MODIFICATION No. 23554P3127

TITLE : AIR CONDITIONING - COCKPIT - INTRODUCE PROTECTION AGAINST WATER CONDENSATION.

SERVICE BULLETIN No. : A320-21-1072

Blanking of Structural Holes at the Lower and Upper
L and R Windshield front Sections
Figure 9, Sheet 2

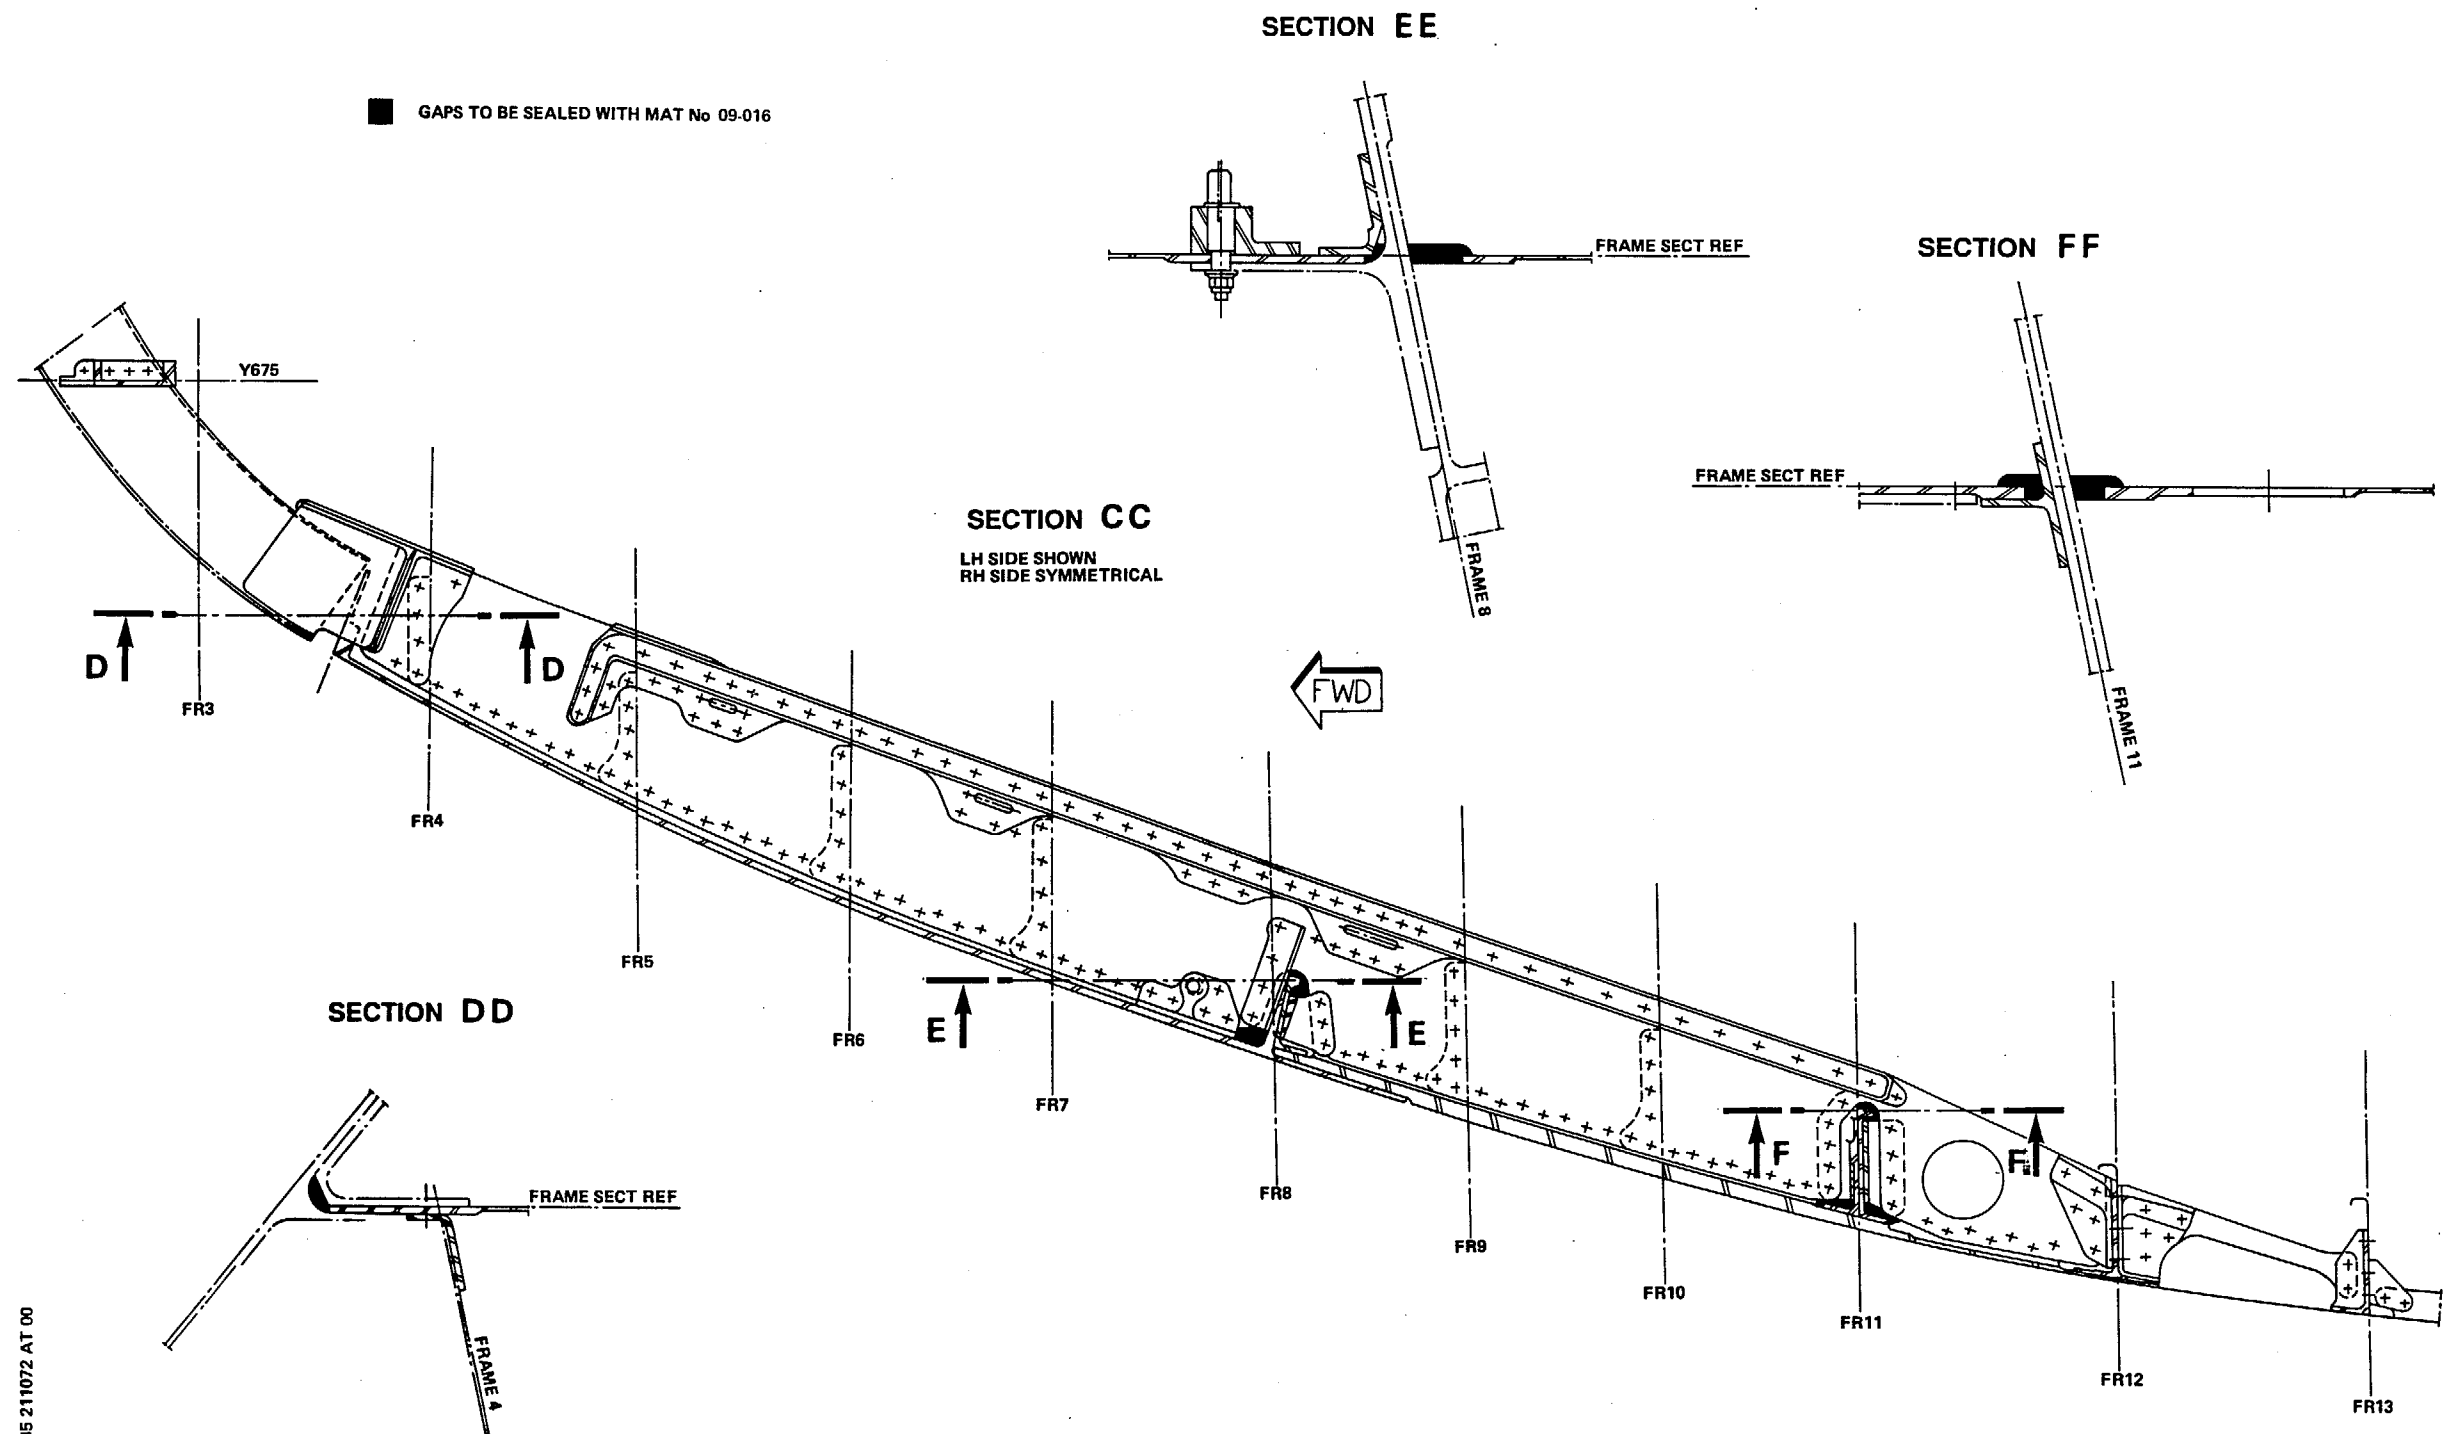
- (9) Installation of sealant on the structural holes at the lower and upper L and R windshield front sections

At the frames 8 and 11 intersection holes, install sealant Mat. No. 09-016.
